**TYPEs : MCB
RCCB
ISOLATOR**

Indication change of packing label for MCB, RCCB and ISOLATOR

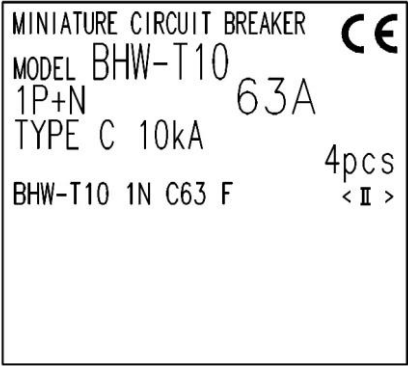
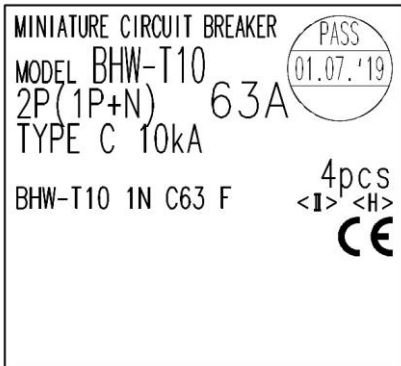
- (1) Packing date will be indicated additionally.
- (2) Indication of No. of poles will be changed for BHW-T10 (0.5 to 63A).
 - (a) 1P+N will be changed to 2P(1P+N).
 - (b) 3P+N will be changed to 4P(3P+N).

Before change	After change
<p>Ex. BHW-T10 2P(1P+N) Type C 63A</p> <p>(2) Indication of No. of poles: 1P+N</p>  <p>MINIATURE CIRCUIT BREAKER CE MODEL BHW-T10 1P+N 63A TYPE C 10kA BHW-T10 1N C63 F 4pcs < II ></p>	<p>(1) Packing date</p> <p>(2) Indication of No. of poles: 2P(1P+N)</p>  <p>MINIATURE CIRCUIT BREAKER CE MODEL BHW-T10 2P(1P+N) 63A TYPE C 10kA BHW-T10 1N C63 F 4pcs < I > < H > CE</p> <p>PASS 01.07.'19</p>

- (1) Addition of packing date: To improve traceability
- (2) Indication change of No. of poles for BHW-T10 (0.5 to 63A): To unify the indications with BVW-T
